Staff Report Z-SP-7- 18-6

January 17, 2019

Camelback East <u>Village Planning</u> Committee Meeting Date:	February 5, 2019
Planning Commission Hearing Date:	March 7, 2019
Request From:	<u>C-2</u> (1.50 acres)
Request To:	<u>C-2</u> <u>SP</u> 1.50) acres
Proposed Use:	Self-service storage and all underlying C-2 uses
Location:	Northeast corner of 7th Street and Flynn Lane
Owners:	Jeff Clements, Flynn 720, LLC
Applicant/ Representative:	Michelle Bach, RKAA
Staff Recommendation:	Approval, subject to stipulations

SITE PLAN

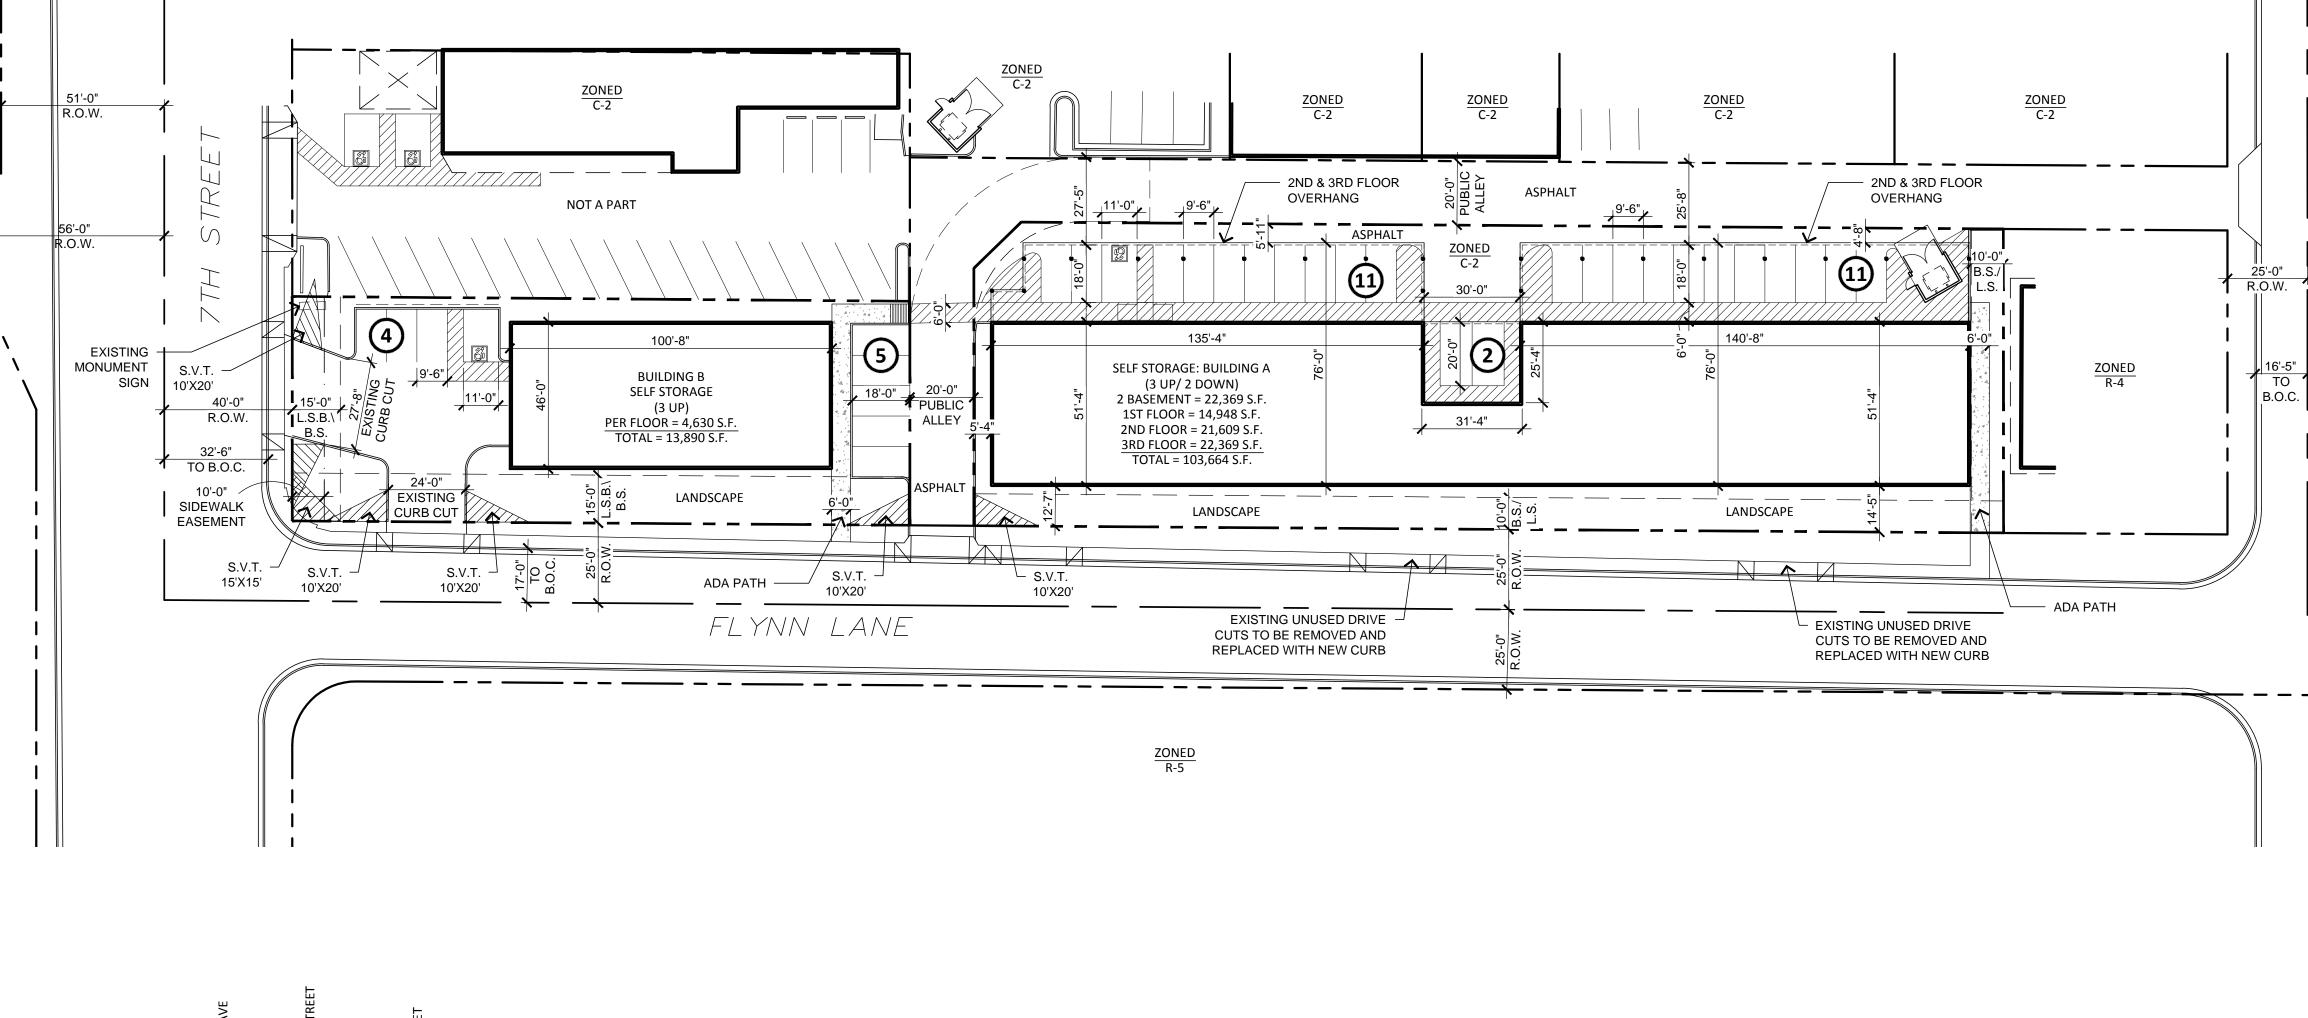
Intermediate Commercial (C-2)		
<u>Standards</u>	Requirements	Provisions on the Proposed Site Plan
Building Setbacks		
	South (Building A and B): For structures exceeding two stories and 30 feet, Average 30-foot setback	South (Building A): 10 feet (not met)*
Adjacent to street, (Flynn Lane and 7th Street)		South (Building B): 15 feet (not met)*
	West (Building B): For structures exceeding two stories and 30 feet, Average 30-foot setback	West (Building B): 15 feet (not met)*
Adjacent to property	North (Building A and B): Adjacent	North (Building A): 5 feet (met)
line	to C-2; 0 feet	North (Building B): not provided

East (Building A): Adjacent to	East (Building A): 10 feet
	R-4; 30 feet for building that are	(not met)*
	3 stories or 42-feet in height	
	East (Building B): Adjacent to	East (Building B): 24 feet (met)
Adjacent to property line	alley and C-2 zoning; 0 feet.	
	West (Building A): Adjacent to	West (Building A): 5 feet (met)
	Alley and C-2 zoning; 0 feet	
Landscape Setbacks	I

• • •	South (Building A and B):	South (Building A): 10 feet (not
	Minimum 20 feet for up to 50%	met)*
	of the frontage, average 30 feet	- 7
	for structures exceeding two	South (Building B): 15 feet (not
Adjacent to street,	stories and 30 feet in height.	met)*
(Flynn Lane and 7th		linety
Street)	West (Building B): Minimum 20	West (Building B): 15 feet (not
Sileely	feet for up to 50% of the	met)*
	frontage, average 30 feet for	mety
	structures exceeding two stories	
	U U U U U U U U U U U U U U U U U U U	
	and 30 feet in height.	North (Duilding A and D), Nore
	North (Building A and B): 0	North (Building A and B): None
	feet	(met)
Adjacent to property line	East (Building A): 10 feet	East (Building A): 10 feet (met)
	East (Building B): 0 feet	East (Building B): None (met)
	Most (Building A): 0 fast	Mast (Building A), Nana (mat)
Lat Cavaraga	West (Building A): 0 feet	West (Building A): None (met)
Lot Coverage	50% maximum	62% (not met)*

30 feet maximum	35 feet (not met, companion
Building Height		rezoning case Z-77-18) for height
		waiver
Parking Requirements	1 space per 35 storage	33 (met)
	units = 26

4. The conceptual site plan proposes two self-service storage facilities on separate parcels. The project will be phased with anticipation that the eastern parcel, with Building A, be developed first. The eastern parcel depicts a three story building with two basements, totaling 103,664 square feet with access along Flynn Lane and 8th Place, through a commercial alley to the north. In regard to access to Building A, the applicant would be required to obtain a variance to access the site from Flynn Lane and 8th Place because the special permit district standards for self-service storage facilities require that the site have direct access from an arterial street. The applicant would also be required to obtain a variance to allow maneuvering in the alley. If this is not feasible, the applicant may pursue a cross access agreement and abandonment of the commercial alley. The request makes no modifications to the existing access to and from the site. Covered parking is provided along the north of the building

The western parcel, containing Building B, depicts a three story building, totaling 13,890 square feet with access from 7th Street and Flynn Lane. Building B has direct access off of a major arterial street and therefore requires no further entitlements to access the site. Parking for the facility is proposed along the eastern property line. Staff has recommended that the uncovered surface parking lot area be landscaped with a minimum 2-inch caliper shade trees that are dispersed throughout. Trees within surface parking lot area will help reduce the urban heat island effect and will provide thermal comfort for guests going to and from their vehicles. This requirement is addressed in Stipulation No. 6. The proposed development is adjacent to a residential property to the east. To mitigate any impacts of the proposed development staff has recommended that screening in the form of landscaping be provided adjacent to residential properties. This is addressed in Stipulation No. 5.

*The site shall be modified to meet the requirement or a variance shall be obtained.

- 1. Any Outdoor storage shall be screened by a minimum 8-foot solid decorative wall, as approved by the Planning and Development Department.
- 2. The development shall be in general conformance with the elevations date stamped January 22, 2019, as approved by the Planning and Development Department.

- 5. Minimum 3-inch caliper trees, planted 20 feet on center, or in equivalent groupings, shall be planted along the eastern property line adjacent to the multifamily zoning district development, as approved by the Planning and Development Department.
